INCH-POUND
MIL-PRF-28750/10C
AMENDMENT 3
15 December 2000
SUPERSEDING
AMENDMENT 2
29 February 2000

PERFORMANCE SPECIFICATION SHEET

RELAY, SOLID-STATE, SEALED, CLASS I, OPTICALLY ISOLATED, ZERO VOLTAGE TURN-ON, 25 AMPERES, 250 V MAXIMUM, 400 HZ, POWER SWITCHING, SPST (N.O.)

This amendment forms a part of MIL-PRF-28750/10C dated 1 February 1999, and is approved for use by all Departments and Agencies of the Department of Defense.

FIGURE 5. Broadband conducted emissions."

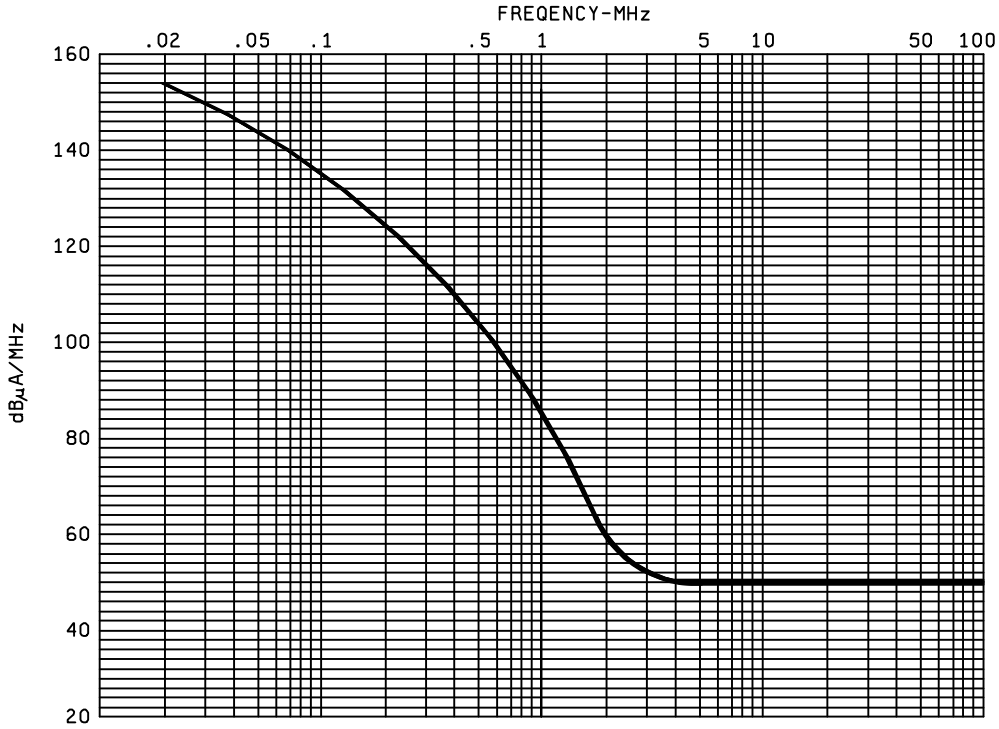
* Add a figure 5:

* Add a paragraph: “Electromagnetic interference: Maximum broadband conducted emission on power lines with 115 V ac, 400 Hz, 10 amperes resistive load during steady state and switching conditions (see figure 5).”
